**County of Loudoun**  
**Department of Planning**  
**MEMORANDUM**

**SUBJECT: SPEX 2007-0029, West Spine Plaza 2<sup>nd</sup> Referral**

**PROJECT DESCRIPTION**

Figure 6

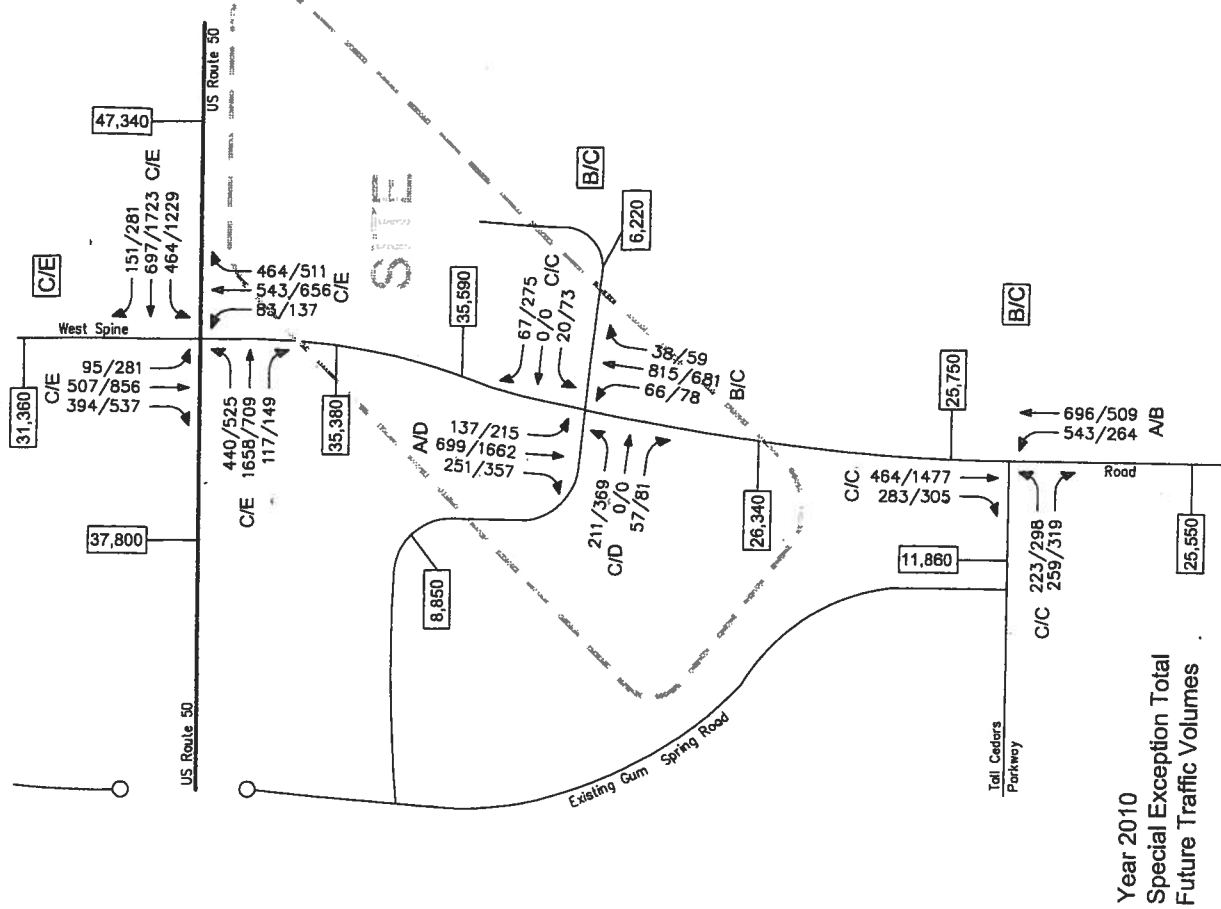
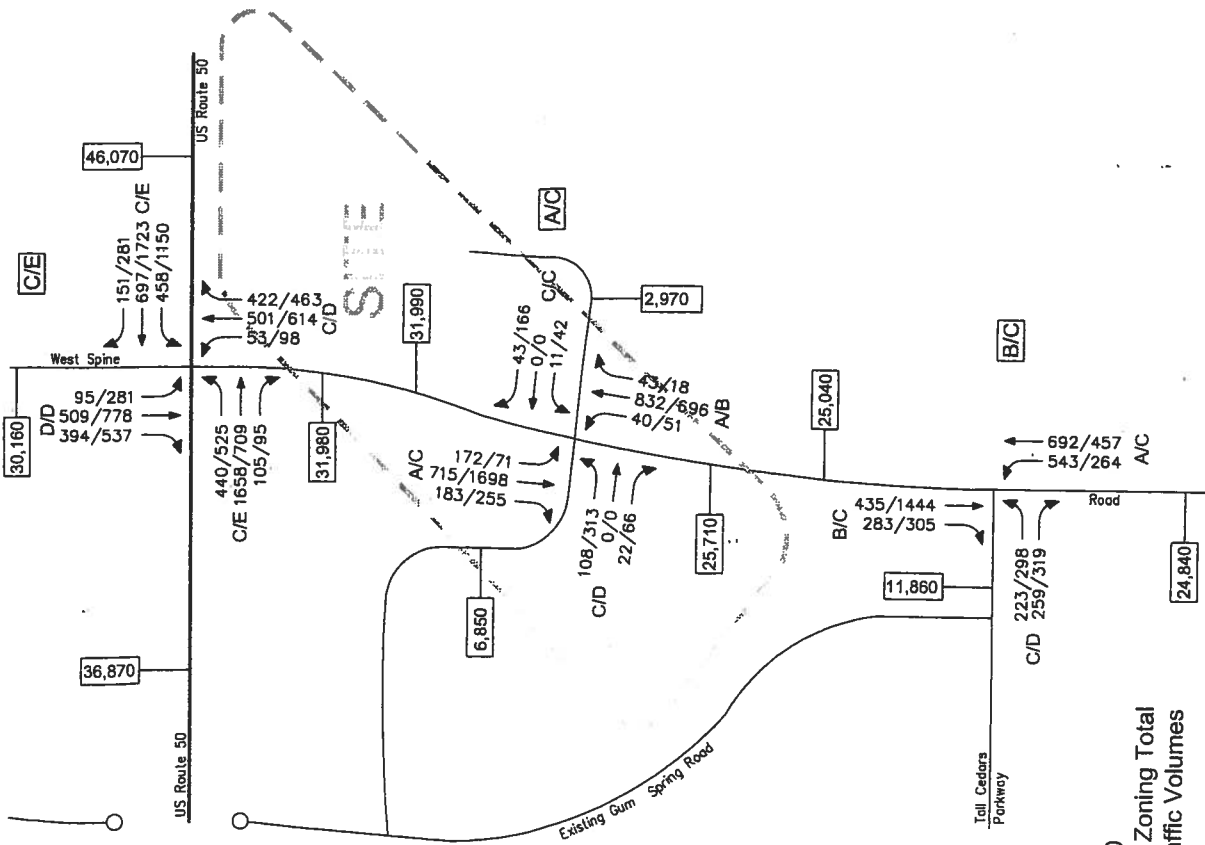
6. Figure 6 – The left turn volume on some movements along the network is close or exceeds 300 vph. Additionally Synchro indicates excessive 95<sup>th</sup> percentile queue lengths for some of these movements. We recommend performing a left turn lane analysis to determine the required number of left turn lanes at the intersections. These movements include:

Figure 4

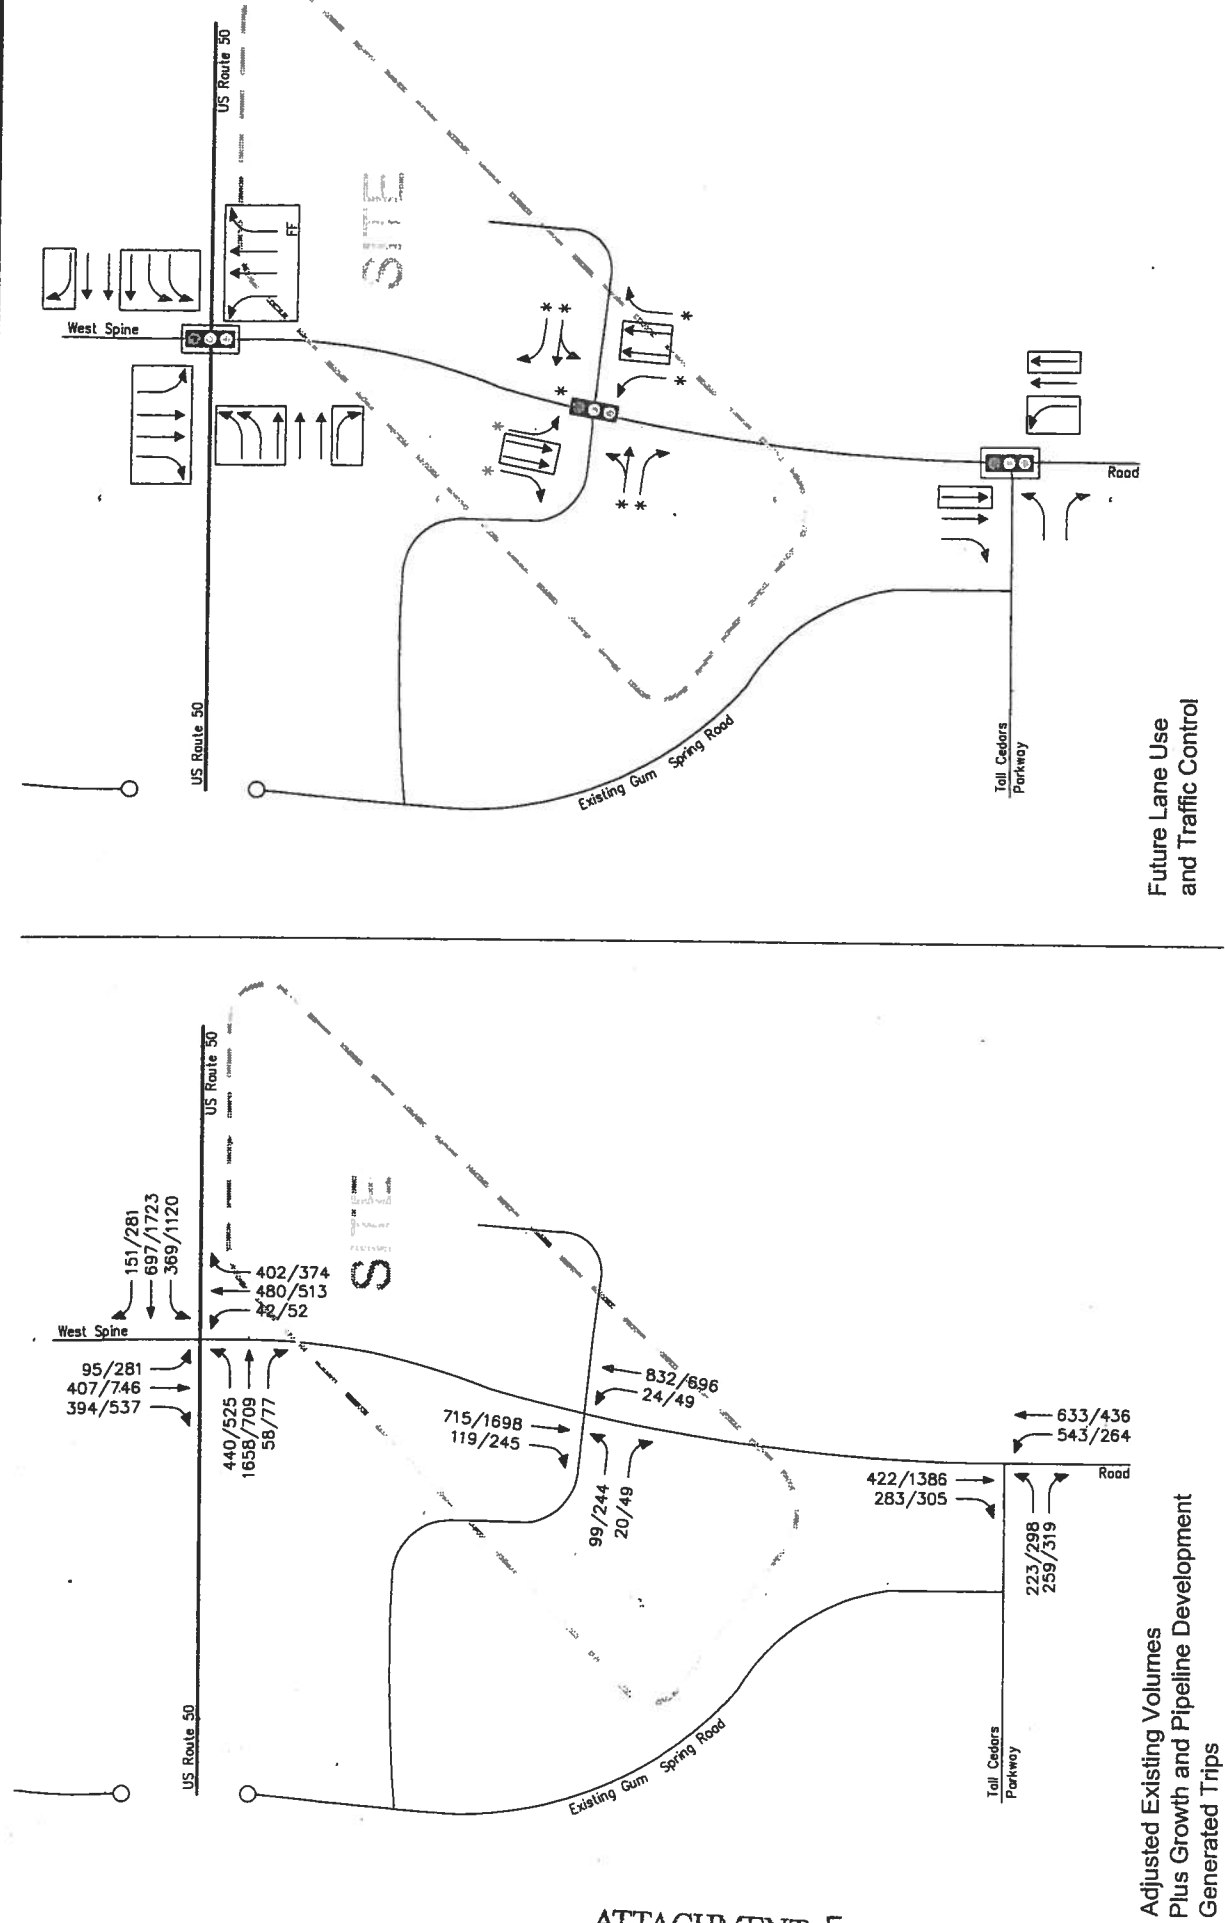
- b. Tall Cedars Rd. / West Spine / Gum Spring Rd., and
  - c. South Point Dr. / West Spine Rd.
7. Figure 5 "Base Traffic Volumes" – the figure shows the existing plus growth plus background traffic for Alternative 1 and Alternative 2. The expectation is that total entry / exit traffic volume into the network would be fairly equal in both alternatives. However, entry / exit volumes to/from east and south of the network are different between the two alternatives by a large order of magnitude. Please explain.
